Emotator 1102/1103 control unit replacement	
TITLE: Emotator_1103	
Document Number:	REV:
Date: not saved!	Sheet: 1/1

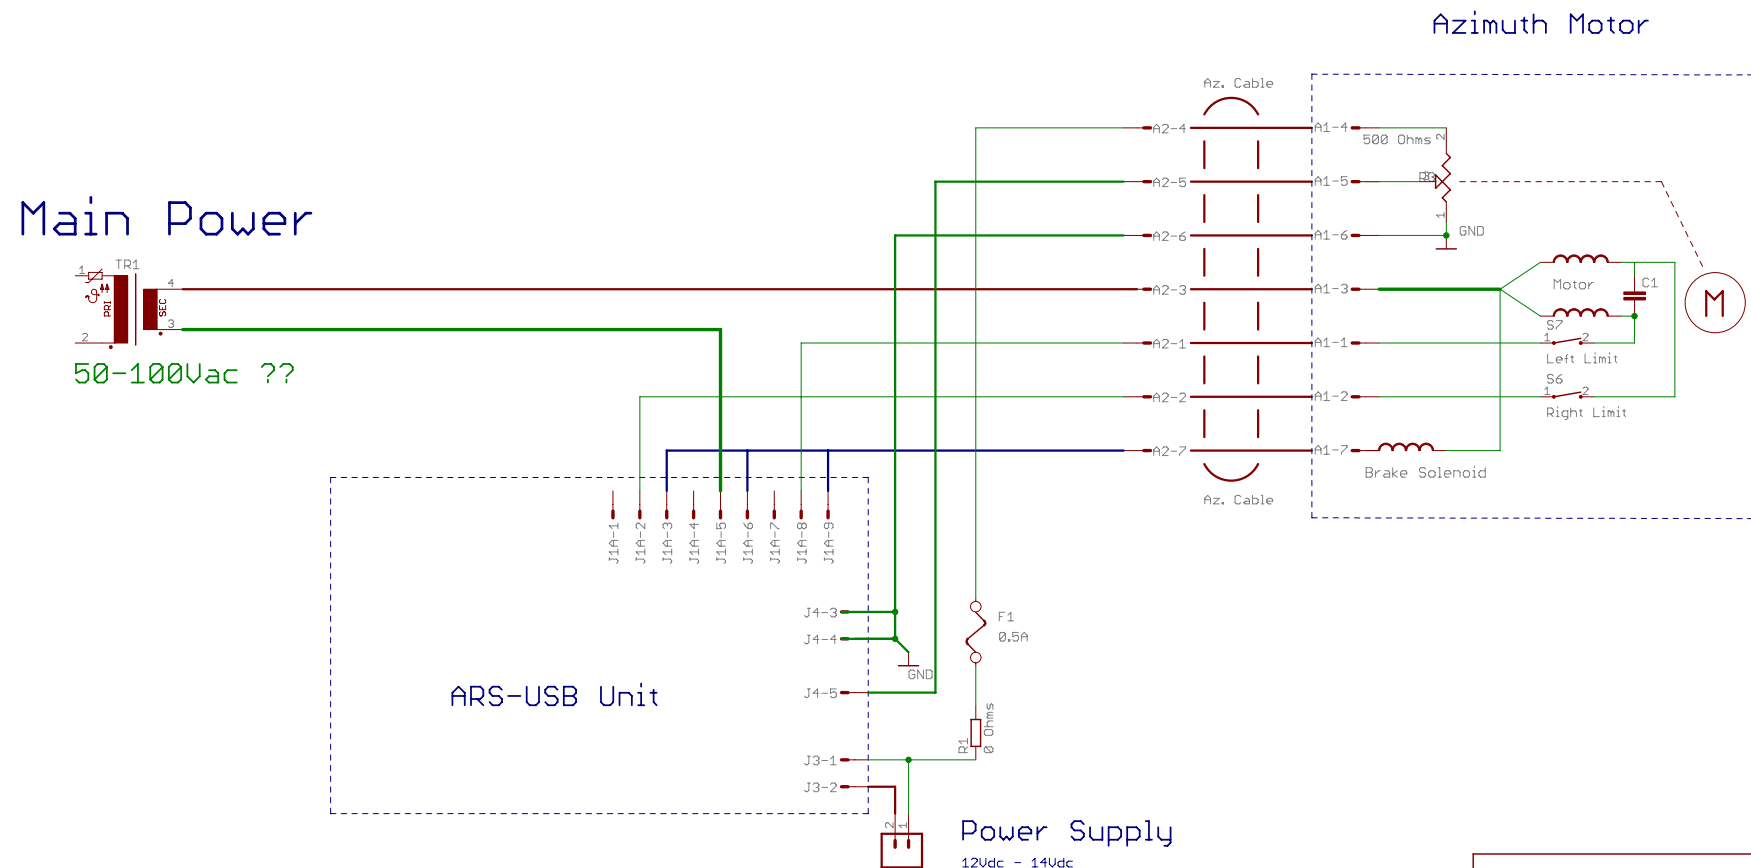
The original schematic indicates the transformer uses a secondary = 100Vac; however the measurement seems to be a 50Vac.
